Technical Service BULLETIN

FRONT SEAT TRACK SQUEAK

'03 4Runner

NV001-03

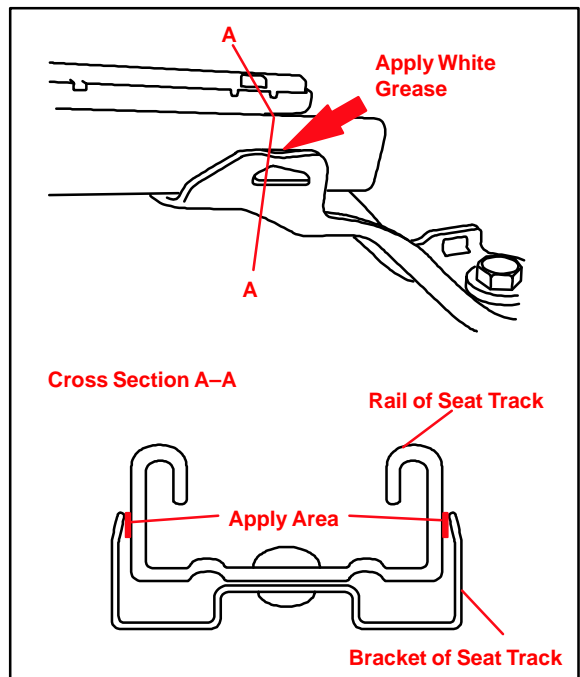
2. Apply white grease between the seat track rail and bracket as shown.

- When applying lubricant to the seat track, cover the carpet with paper or sheet plastic to protect from over spray.
- There are a total of 8 apply areas. Two at the front and two at the rear of each of the two seat tracks.
